# **STS Pulsed Dipole Engineering Design Review Mechanical Design**

Sergey Cheban, PhD

04-16-24

# TEMPERATURE SWITCH

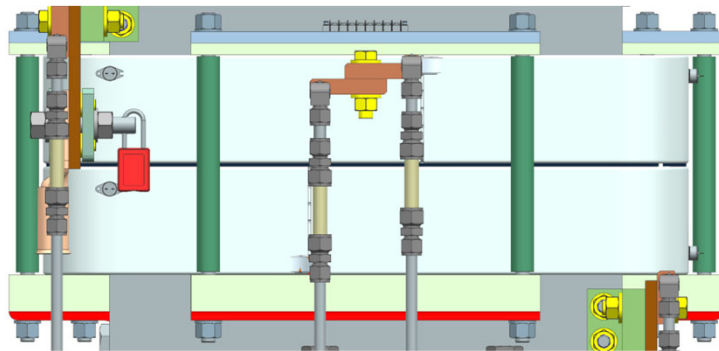
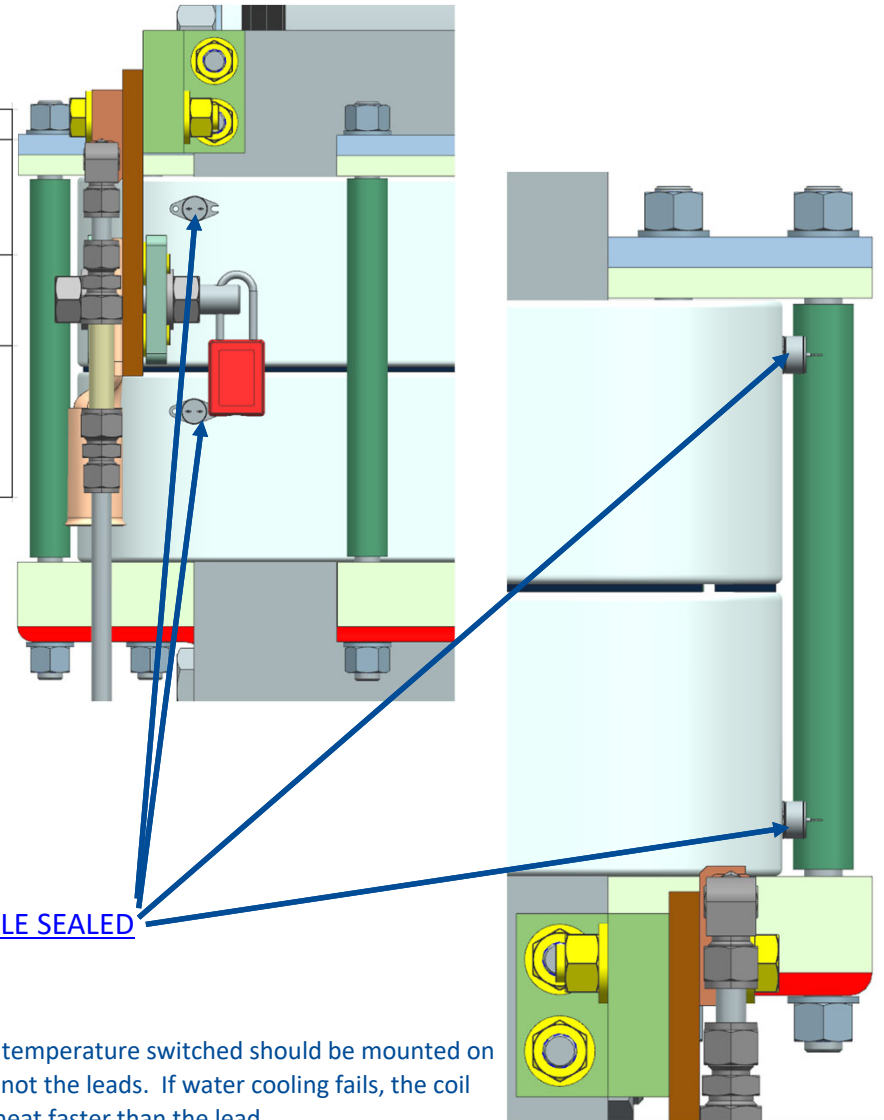
PDR: The temperature switched should be mounted on the coils, not the leads. If water cooling fails, the coil bulk will heat faster than the lead.

# MANIFOLD ASSEMBLY

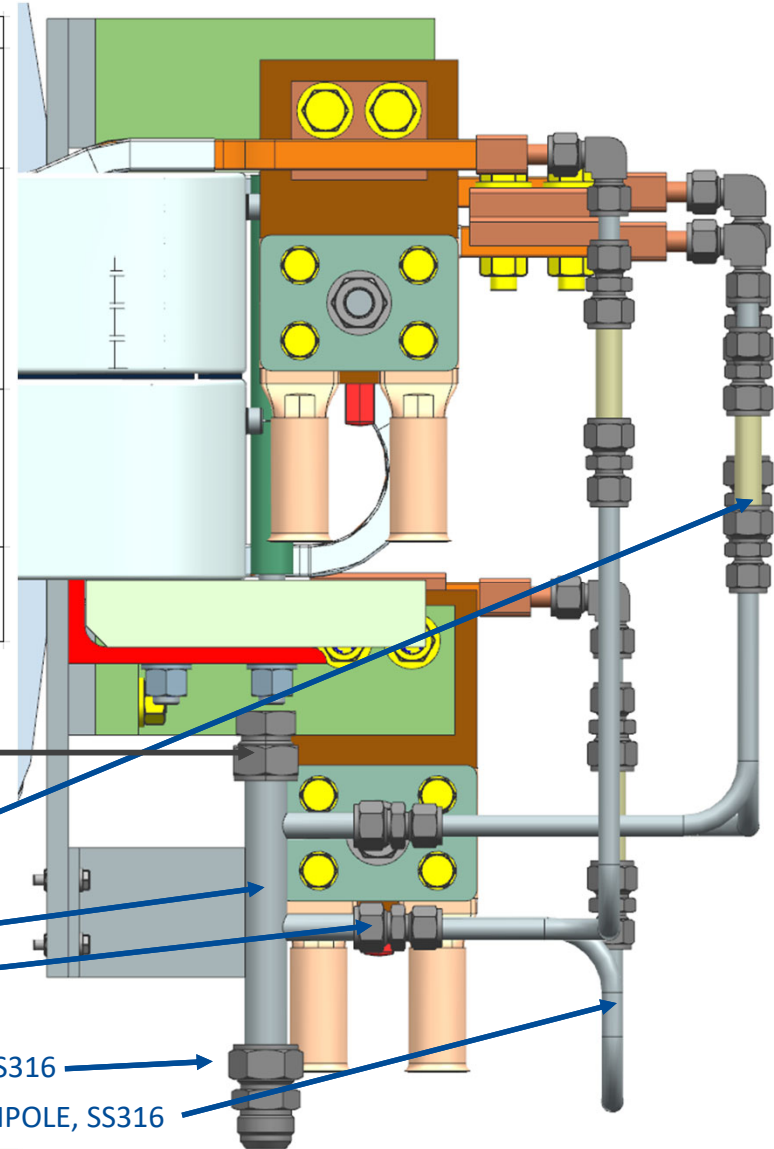
PDR: A concern is the proximity to each other of cooling tubes that have a potential difference between them. Recommend moving the PEEK insulating breaks to close to the electrical flags.

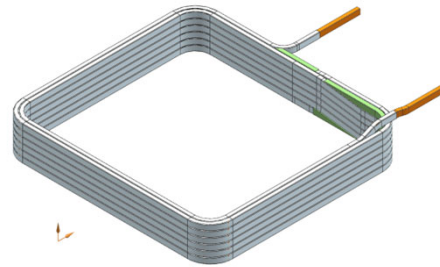
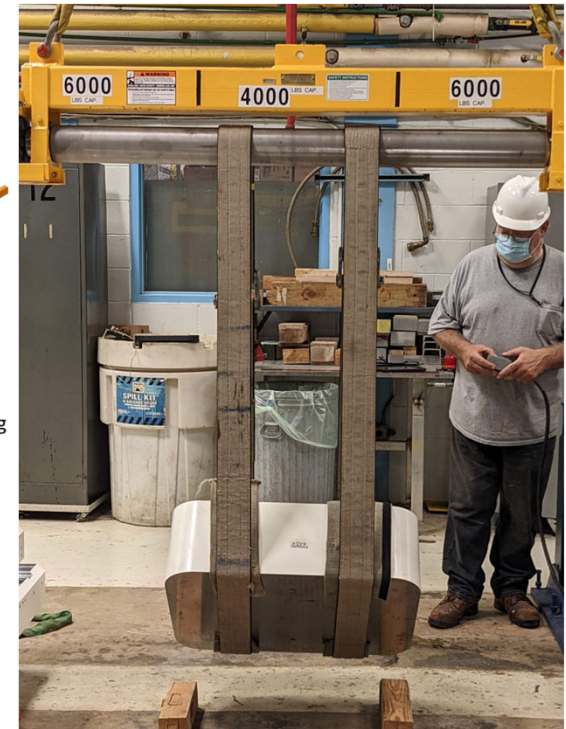
PDR  
(Fixturing will be required for the coil installation)

# STACKING TOOLING

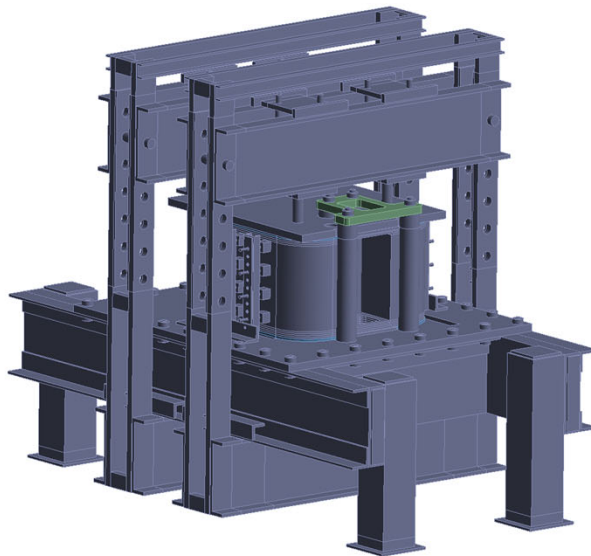
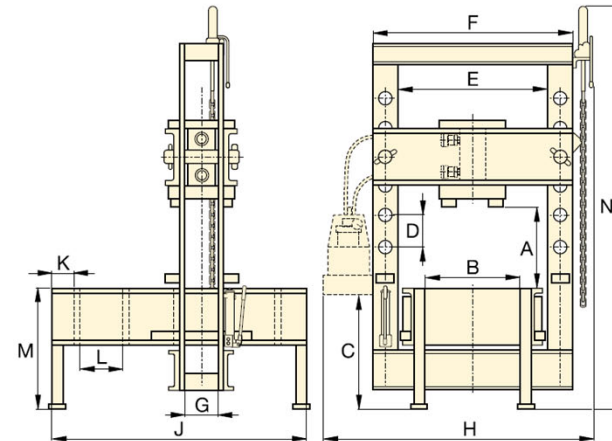
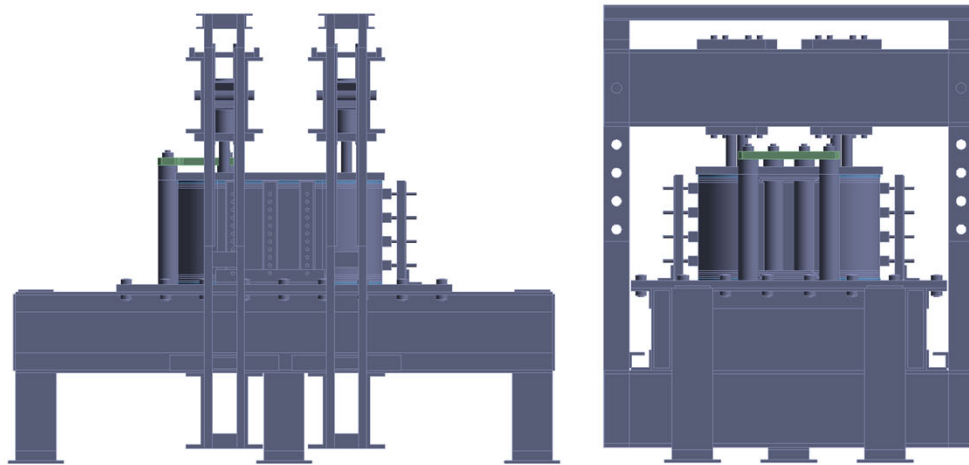
PDR  
(It is planned to use a fixture for stacking the laminations)

[F10196280-TUBE 1](#)    [F10196282-TUBE 3](#)  
[F10196281-TUBE 2](#)    [F10196285-TUBE 4](#)

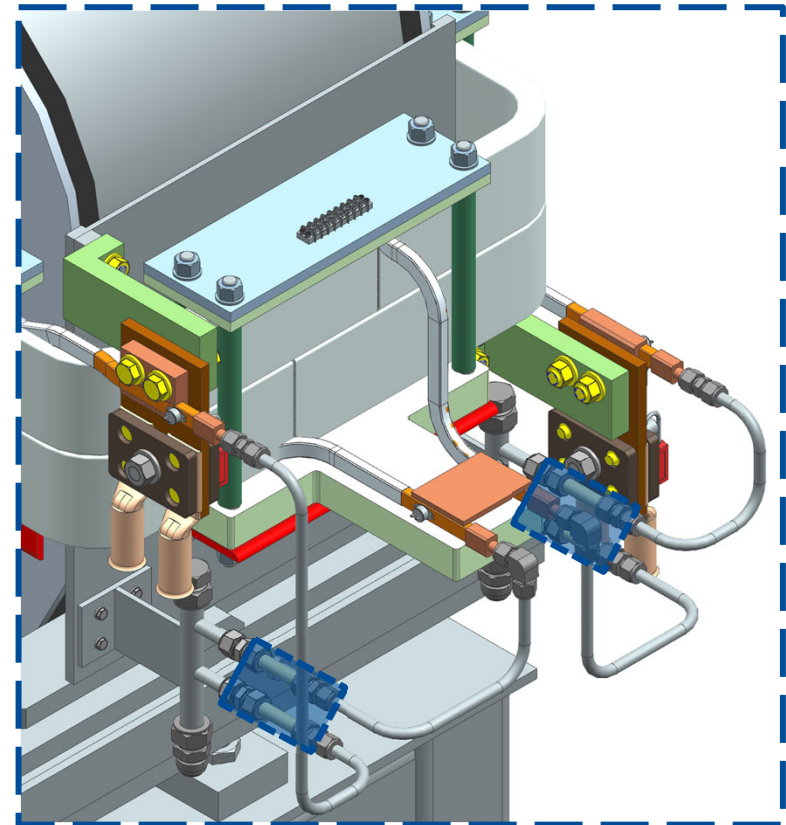
- A concern is the proximity to each other of cooling tubes that have a potential difference between them. Recommend moving the PEEK insulating breaks to close to the electrical flags.
- The expectation is that the cooling tubes will be bent in advance and cut to size on the factory floor. This will be easier after the PEEK tubes have been moved.

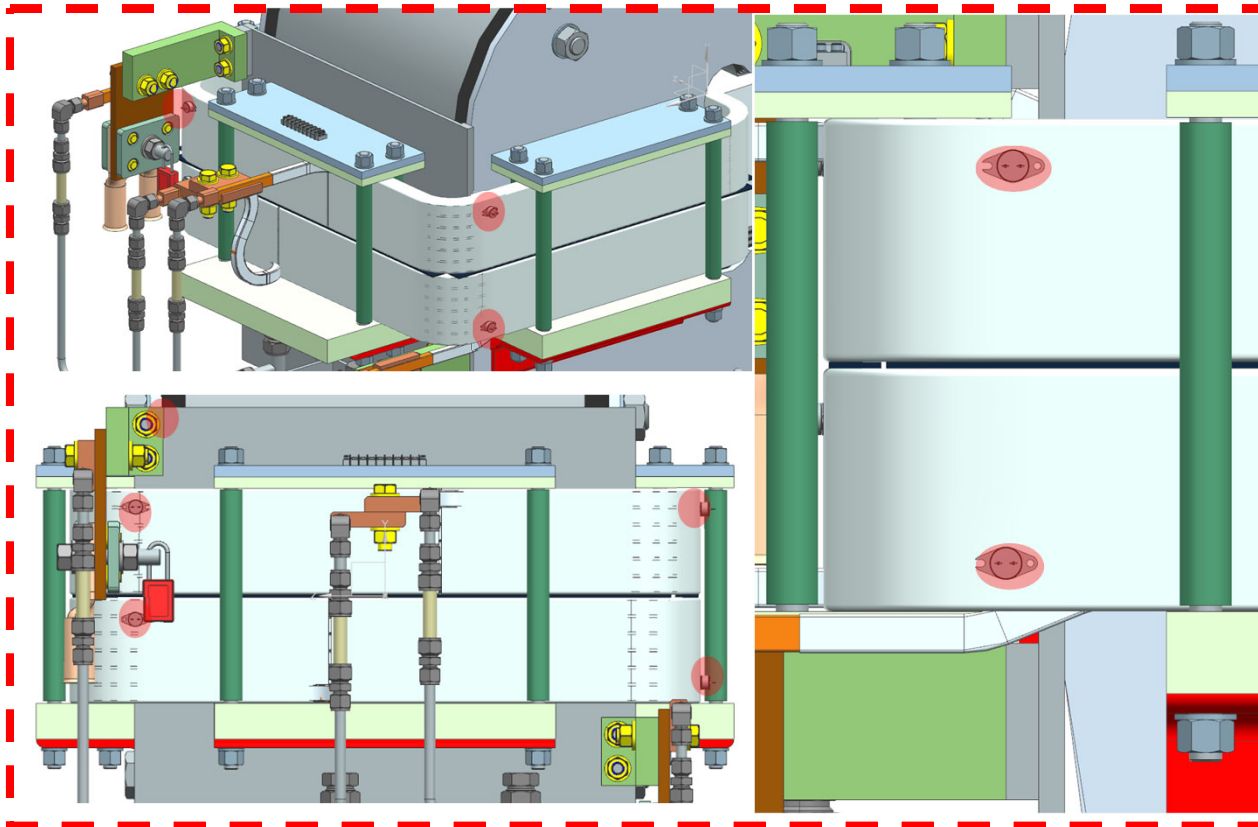
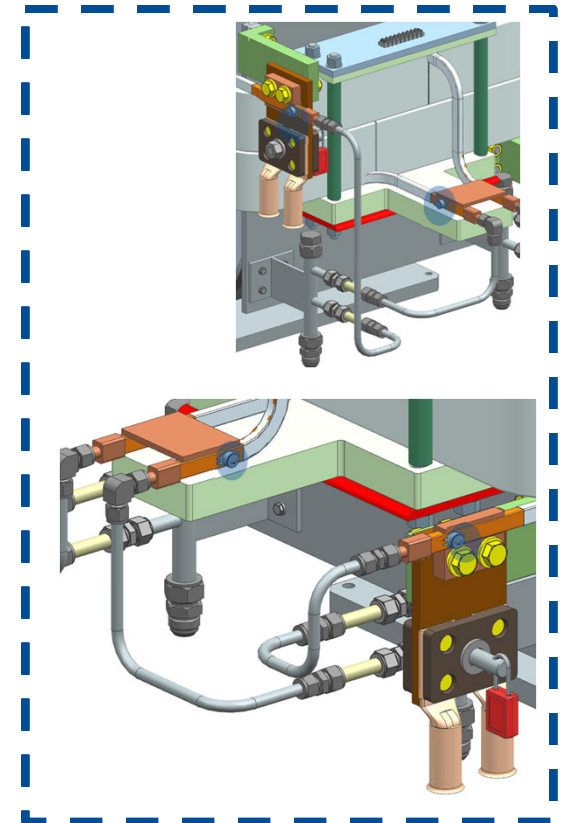
- The temperature switches will be attached by glue, no drilling and tapping into the conductor is planned.
- The temperature switched should be mounted on the coils, not the leads. If water cooling fails, the coil bulk will heat faster than the lead.

FC0109296--;1-1" x 1/8" X 10' NEOPRENE STRIP WITH ADHESIVE

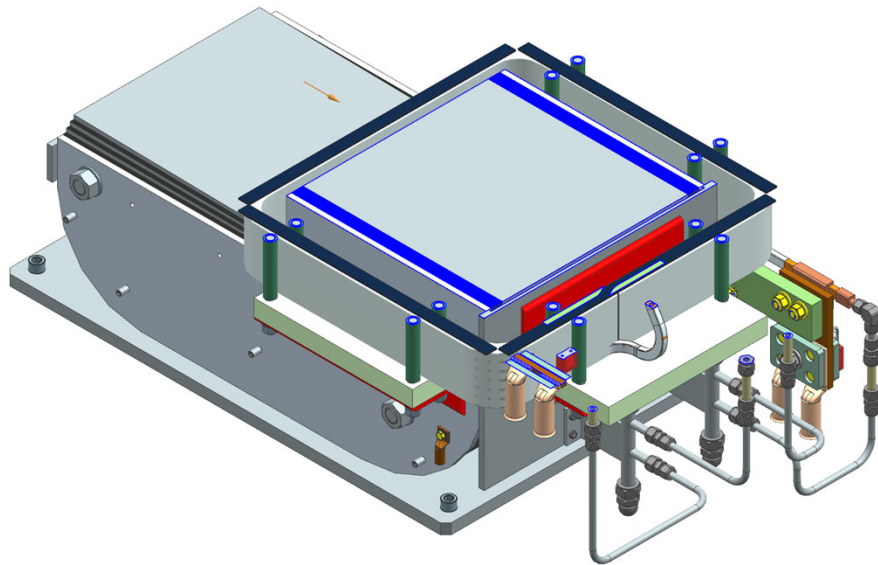
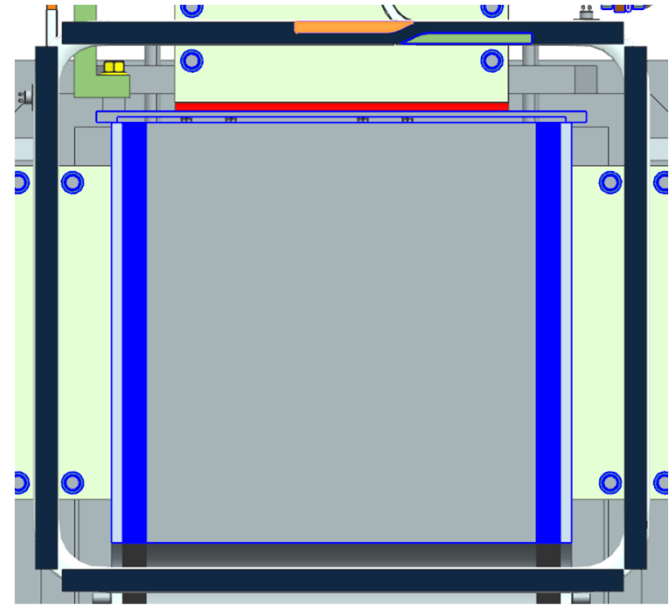
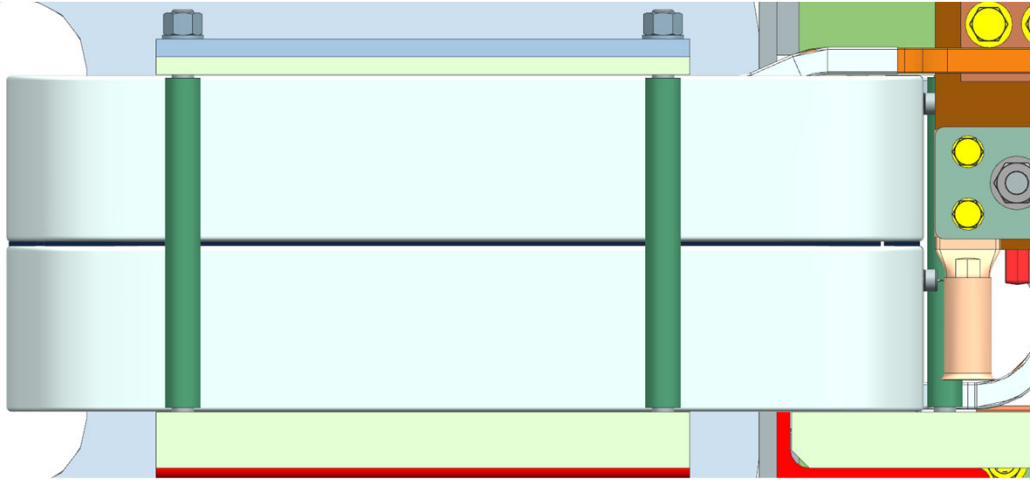
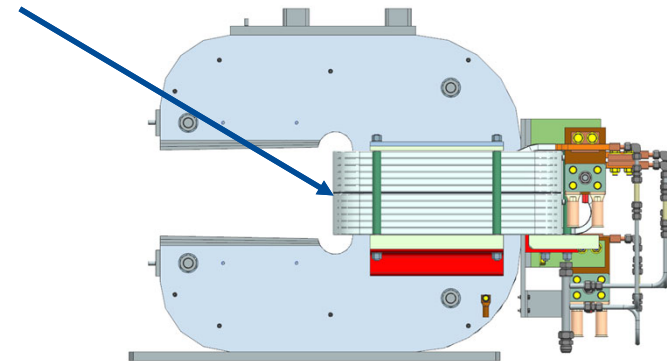
- Recommend thinking about using a compliant material between the coils.

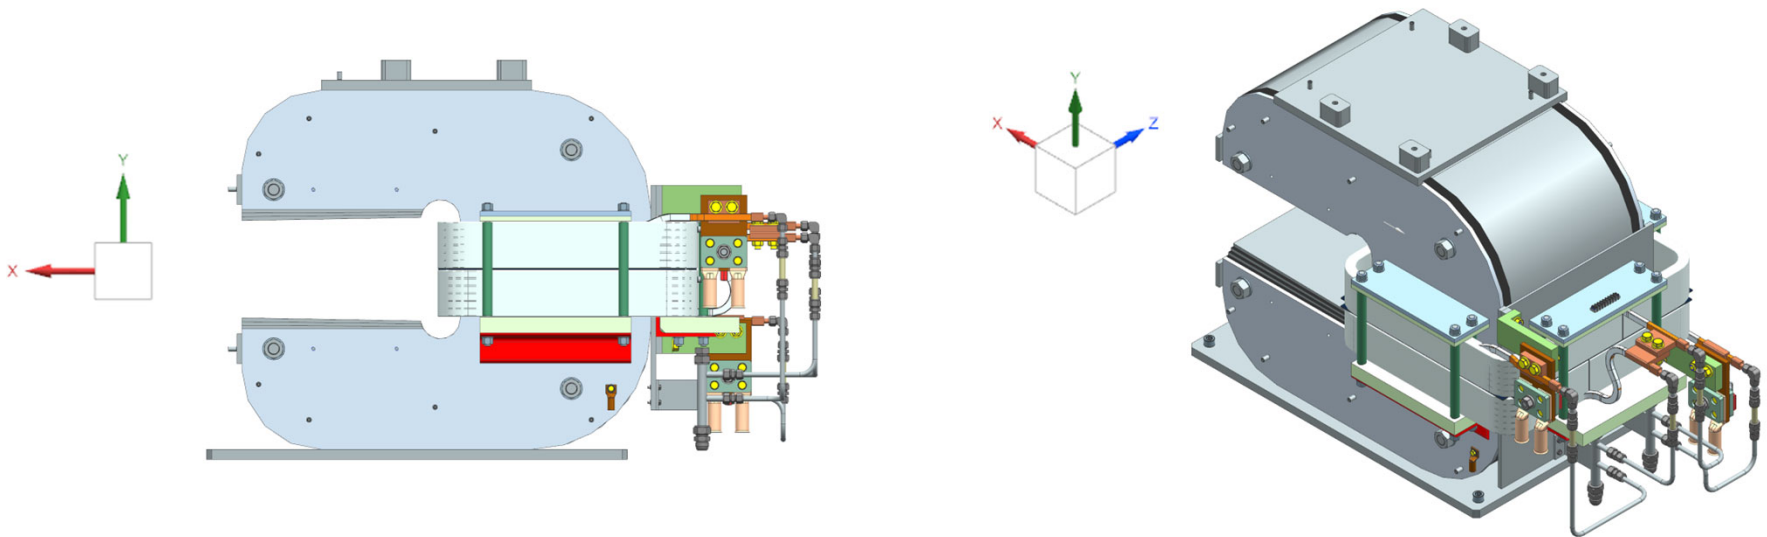
- The coil clamp provides 200 kN of clamping force with the bolts at 75% of their maximum torque. Recommend verifying magnetic forces on the coils.
- Think about whether a spacer is needed between the coil and the core. Friction provides 100 kN horizontal clamping force.
- If horizontal clamping is required for the coil, an opportunity could be to use wedges between the existing 4 G10 rods.
- Magnetic forces  $F_x = -1.4\text{kN}$ ;  $F_y = 7.8\text{kN}$ ;  $F_z = 0.2\text{kN}$ . The friction will be enough to withstand magnetic forces.

# L-SHAPED G10

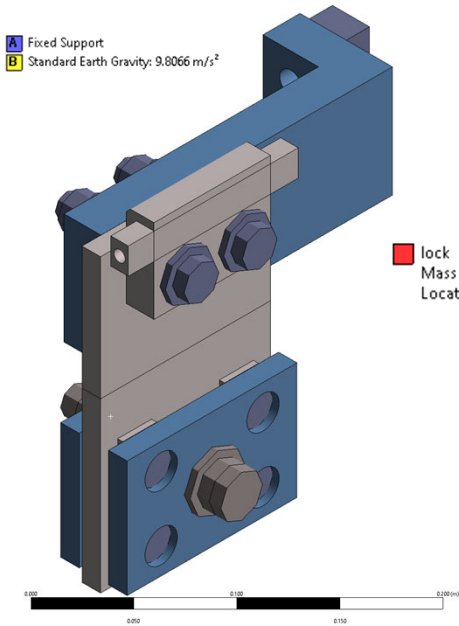
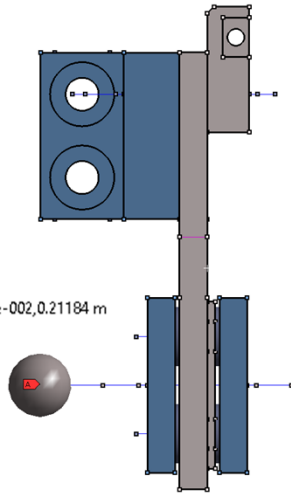
- The L-shaped G10 supports for the power flags could be vulnerable to cracking, be careful with the fiber orientation.

# LIFTING DEFORMATION

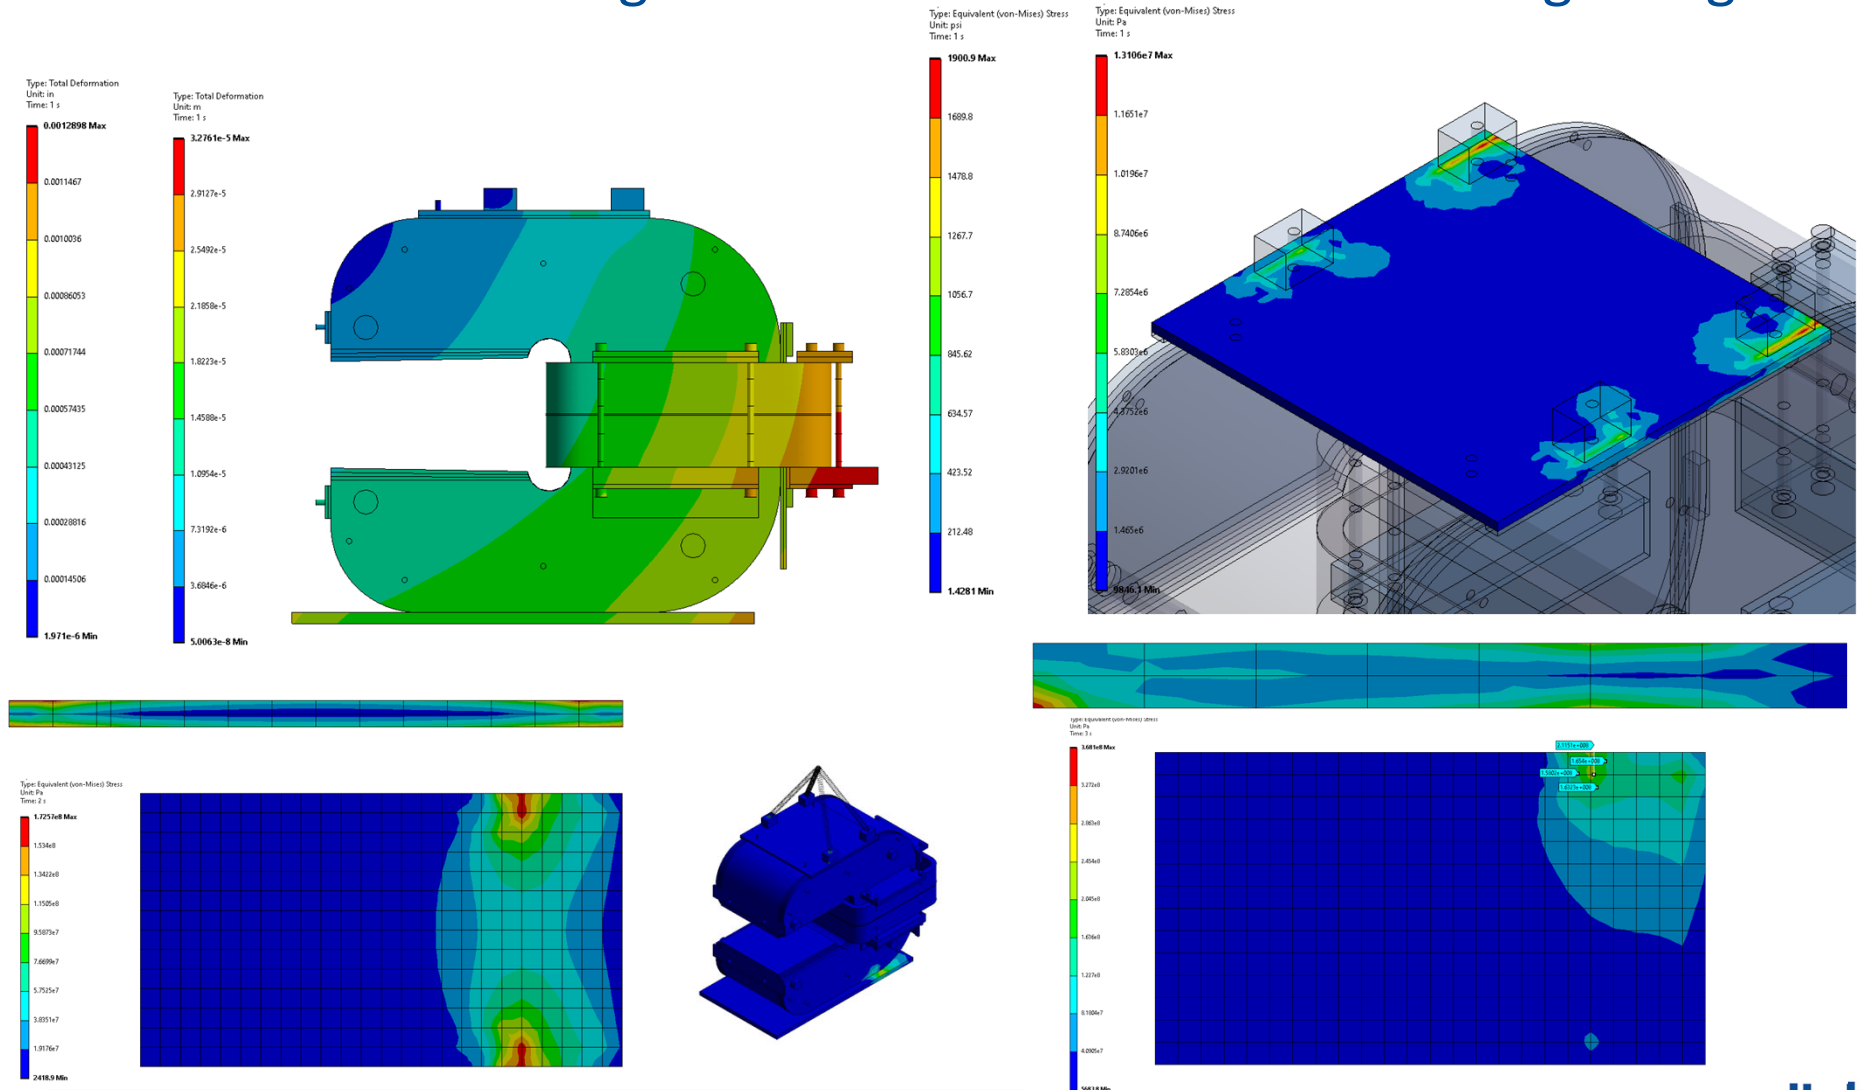
- Recommend checking the deformation that occurs during lifting.
